**Teddington Riverside
(14/0914/FUL)**

**Flood Risk Assessment
(Addendum)**

Report K0358/2

The purpose of the work was to clarify and respond to the specific comments of the Environment Agency, made in July 2014. The Addendum is by way of clarification of the contents of the FRA but does not result in any design changes.

Annotated sketches of the culvert

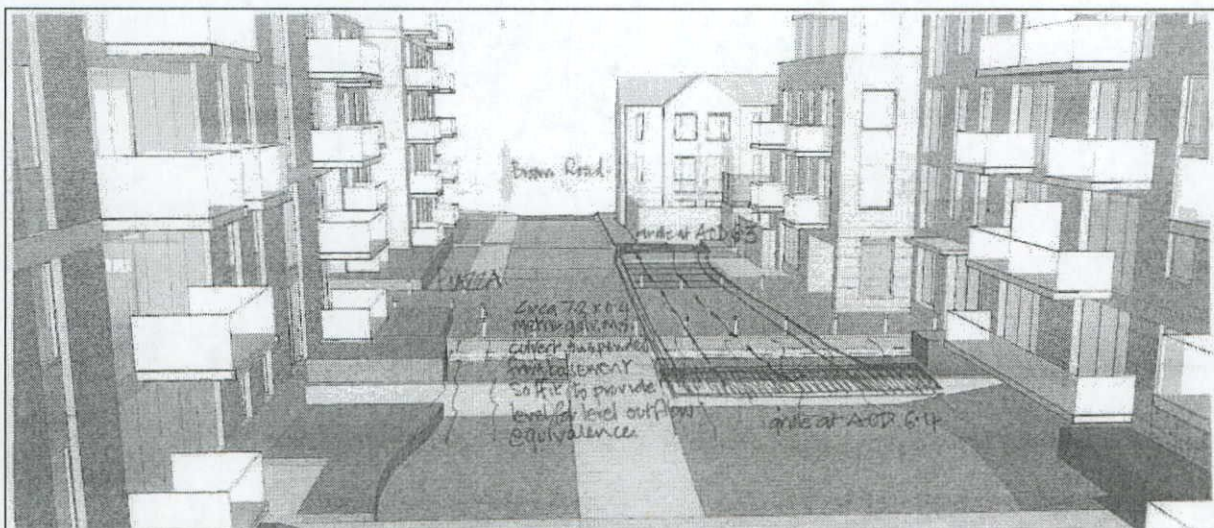
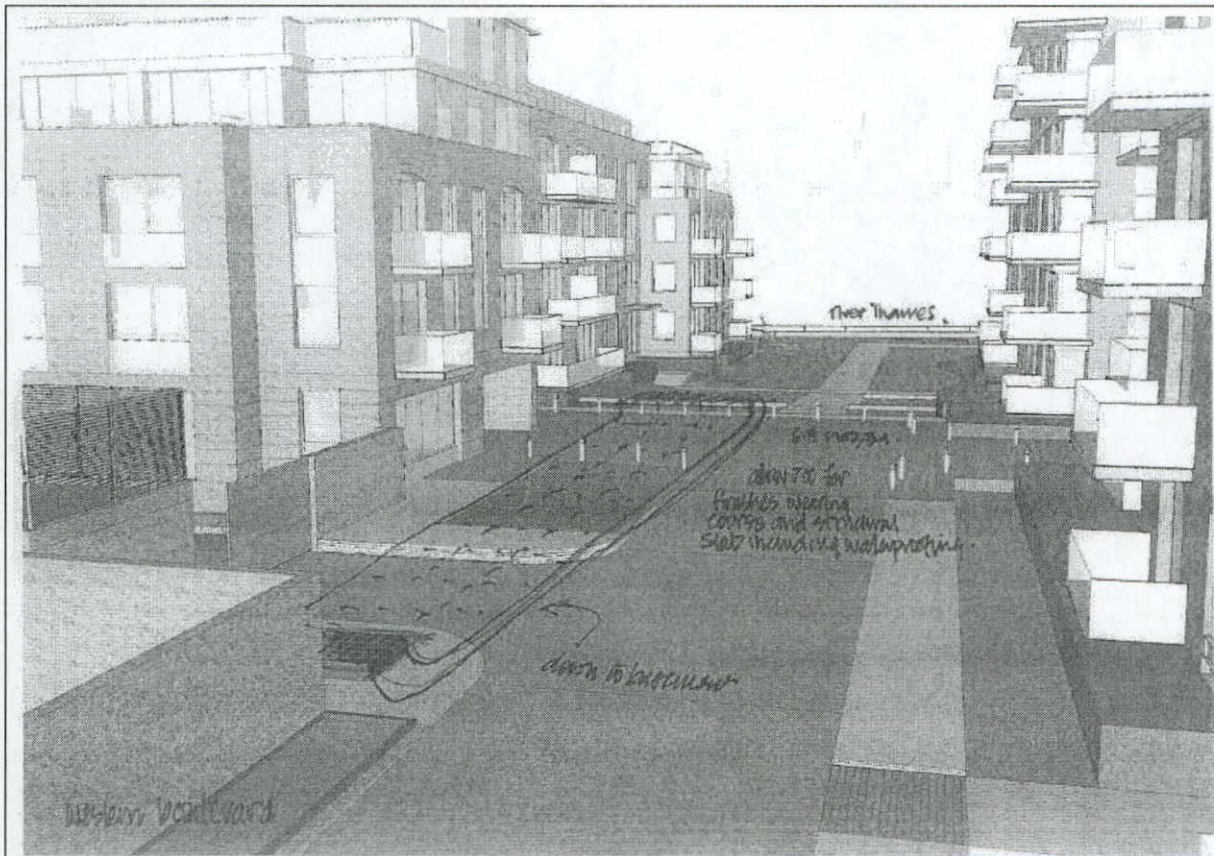
Section 4.2.4 identifies a flow route between the site and broom road at the gatehouse around 7m wide. The ground levels at this point are stated to be 6.41m AOD, indicating flood depths of up of over 0.5m for the design event. It is proposed that this flow path is maintained through a culvert. This is unlikely to sufficiently mimic to existing open flow path situation:

- the proposed culvert and grills are liable to blockages compared to the existing situation
- the proposed culvert has a far smaller cross sectional area compared with the existing open flood route

The proposed flow route should be amended to remove the culvert and maintain an open channel, so the flow route is not restricted potentially increasing flood risk.

The proposed culvert has been moved from the west to east piazza. We would like to discuss how this culvert connects the floodplain in the north and south of site compared with the existing flow route at the gatehouse.

In Section 4.3.1 (page 36 of the FRA), we outline the case for the proposed culvert, which is illustrated below. Note that the hand annotated sketches were prepared for the original planning submission and show the culvert on the western boulevard. It has been relocated to the eastern boulevard and is illustrated more formally in the landscape drawing, in which the culvert is shaded in orange. It should be noted that the existing flow path at the Gatehouse does not behave like an open channel as the gate mechanisms will restrict flow to some extent.

The more important point, as stated in the FRA, is that the flow through the existing flow route and through the proposed culvert will be dictated by relatively small differences in relative level. The hydraulics of the respective flow paths are unlikely to be limiting factors for the flow through on either path.

Note that these drawings were prepared for the original submission when the culvert was located adjacent to the western boulevard. It is now proposed adjacent to the eastern boulevard, though the broad principles remain as shown in the drawings.

Figure 4-22 Drainage Strategy

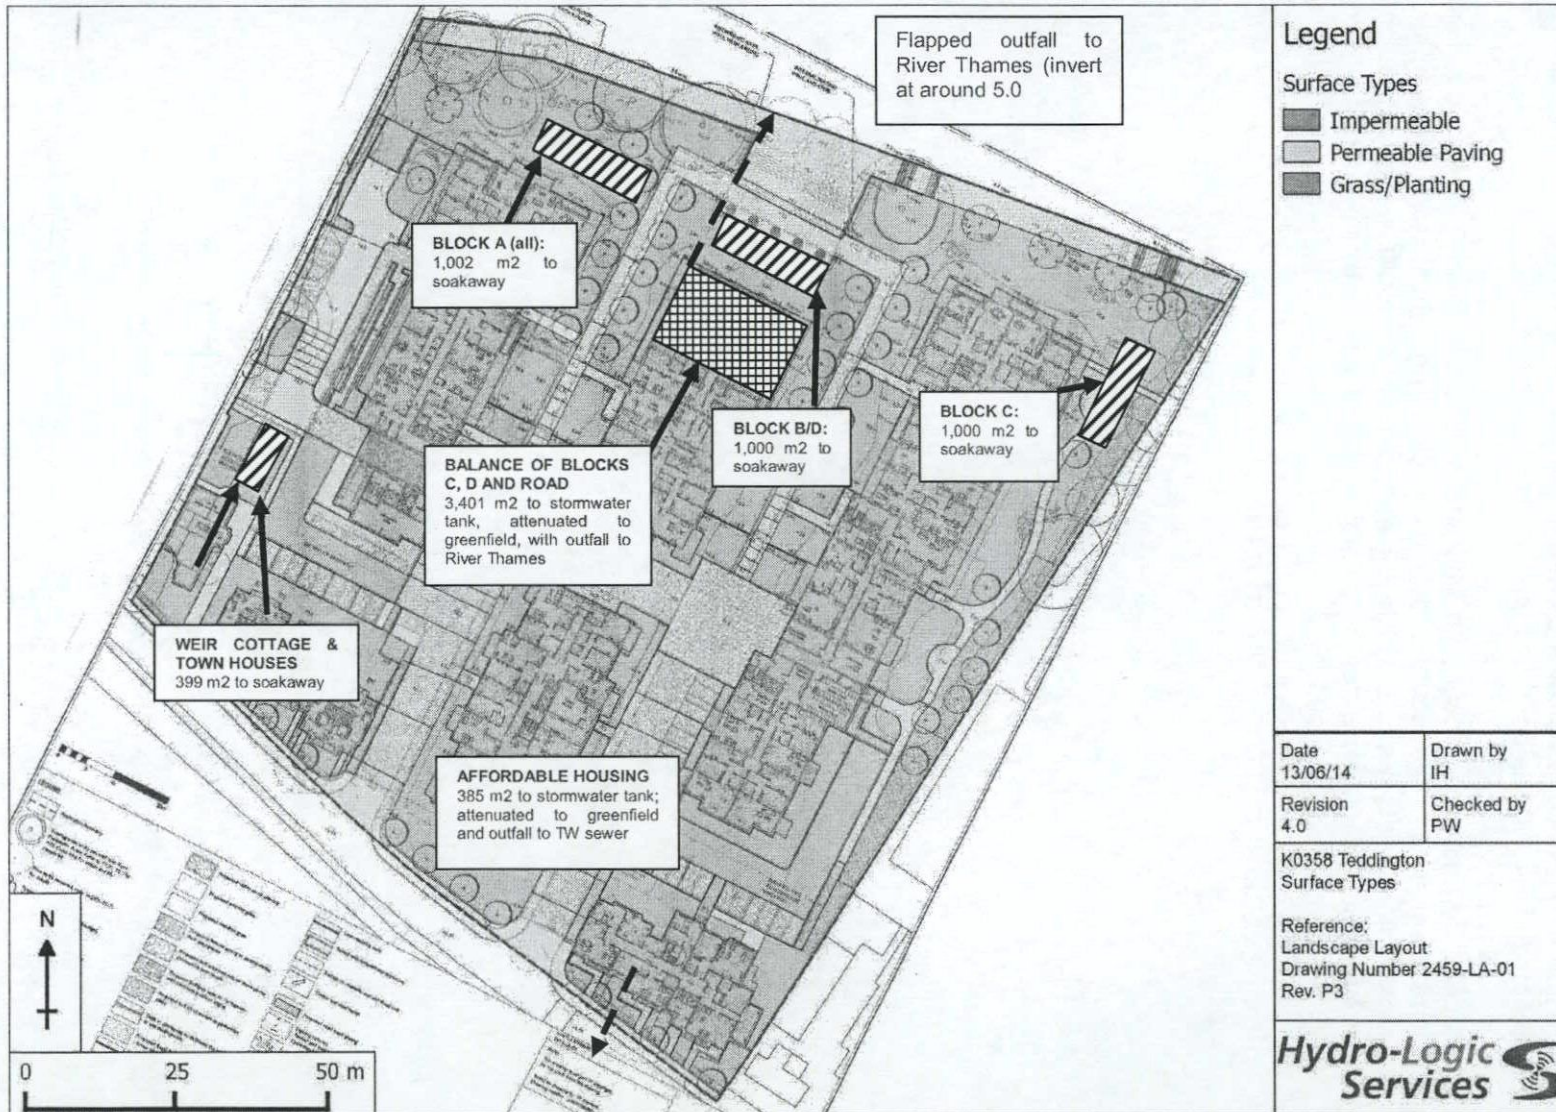
The applicant must demonstrate through their surface water strategy that the proposed development will not create an increased risk of flooding from surface water.

We are supportive of infiltration but a soakage tests should be carried out in support of the soakaways design shown in figure 4.15, for an application seeking full permission such as this one. Infiltration rates should be worked out in accordance with BRE 365. The revised FRA indicates that the tests cannot be carried out currently. Once the tests have been carried out we would be supportive, as outlined in the FRA, of the drainage design being amended to maximise the use of soakaways.

The surface water strategy should be carried out in accordance with the National Planning Policy Framework and Planning Practice Guidance, giving preference to infiltration over discharge to a watercourse, which in turn is preferable to discharge to surface water sewer. Section 4.3.3c indicates runoff from the affordable housing will discharge to the Thames water sewer system; the least sustainable option in this location in the London Drainage hierarchy. It is unclear why discharge to the Thames water sewer system is proposed.

The proposed drainage strategy is shown in Figure 4-22 of the FRA, which has been reproduced below for convenience.

As indicated in Section 4.3.3e (Page 58 of FRA), it is not possible to undertake soakage tests given the current site usage. We have therefore used a conservative value for infiltration coefficient (0.05 m/hr or 1.39×10^{-5} m/s). Furthermore, we have shown that in the even that soakaways are not viable, the attenuation tank under Building B can be increased in size to attenuate all of the runoff that is proposed to drain to the three soakaways. This is regarded as a flexible and robust strategy, that can be refined following the relevant Site Investigations.

The existing arrangements for surface water disposal are described in Section 3; namely the sewer map obtained from Thames Water on Figure 3-6 on page 16 of the FRA and photographs in Figure 3-12 on page 22 showing the line of surface drainage into that sewer. Accordingly, a significant part of the site (possibly 1/3 to 1/2 already discharges, without attenuation, to the Thames Water sewer.

The drainage strategy presented in Section 4.3.3 of the FRA makes provision for the outfall from a small attenuation tank to discharge to the Thames Water sewer. Not only does this represent a substantial **reduction in area** draining to the Thames Water sewer, it is also **attenuated** in the proposed stormwater tank adjacent to the Affordable Housing.
